Job Name: Goulburn Base Hospital and Health Services
Redevelopment

Sketch Title: Ambulance Turning Bay 2

DESCRIPTION
AMBULANCE ENTRY & PARKING

Appendix B

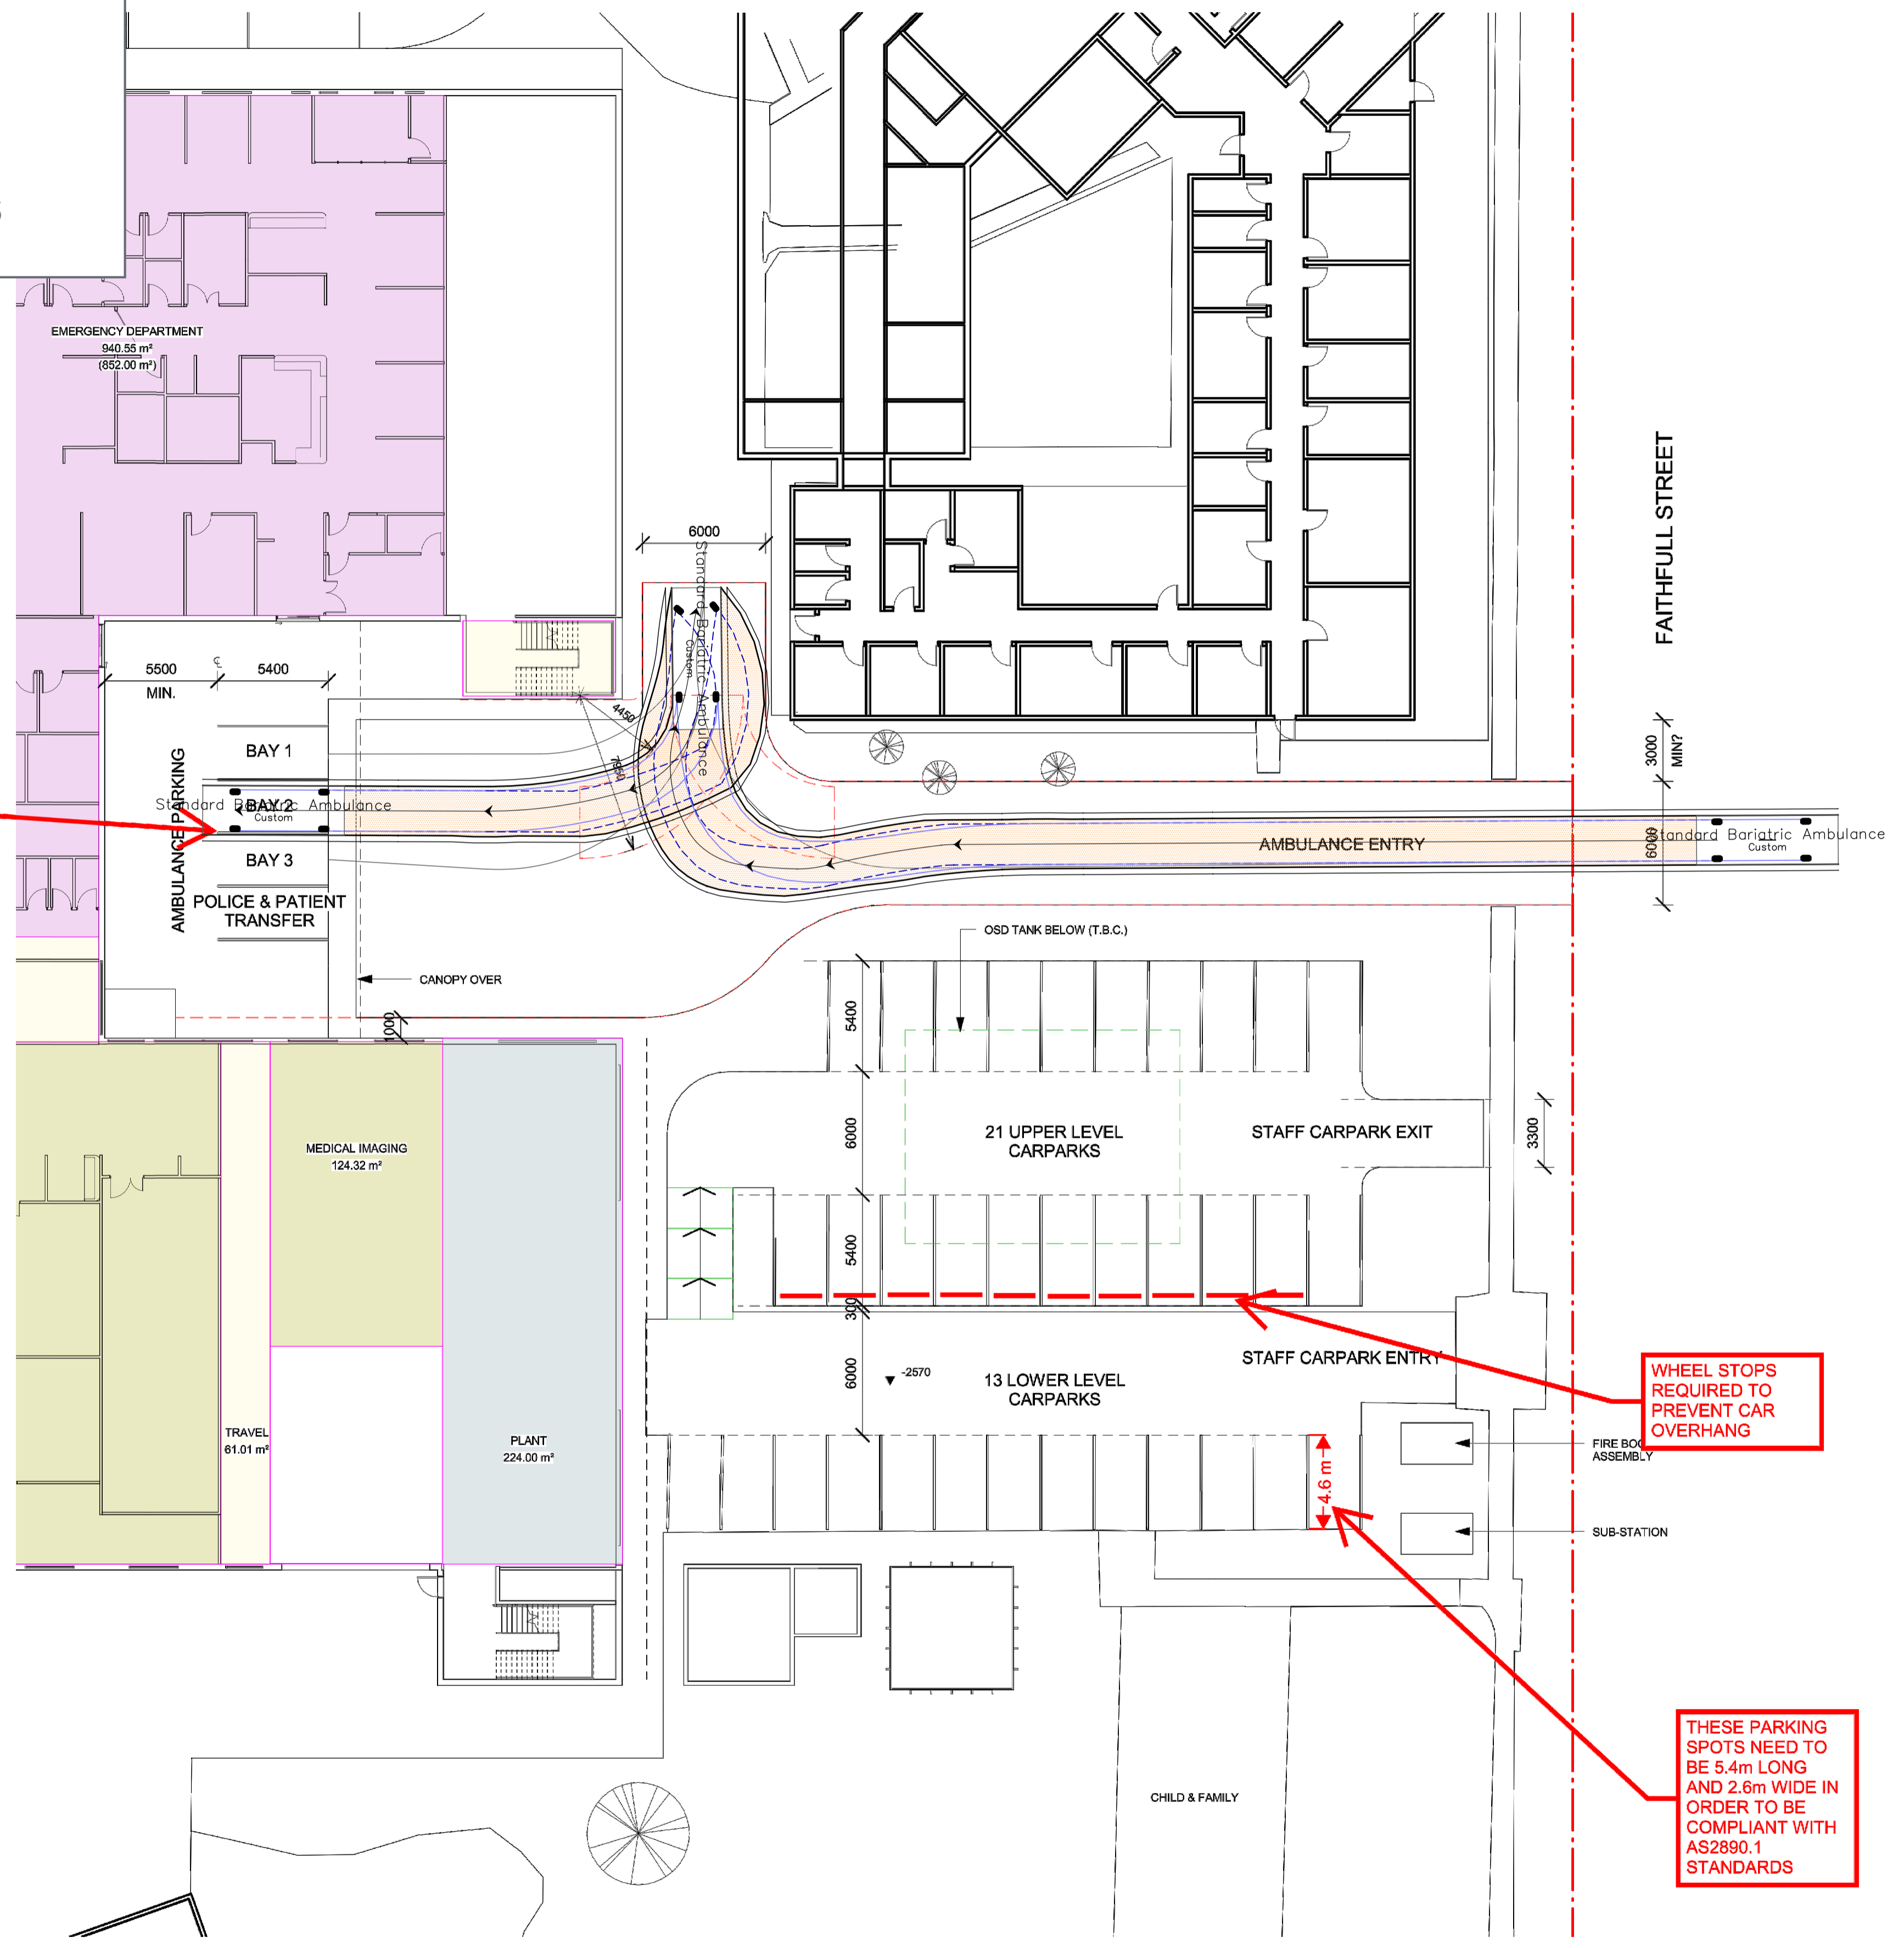
THESE PARKING BAYS NEED TO BE 8m LONG AND 4m WIDE IN ORDER TO SATISFY NSW AMBULANCE REQUIREMENTS

WHEEL STOPS REQUIRED TO PREVENT CAR OVERHANG

THESE PARKING SPOTS NEED TO BE 5.4m LONG AND 2.6m WIDE IN ORDER TO BE COMPLIANT WITH AS2890.1 STANDARDS
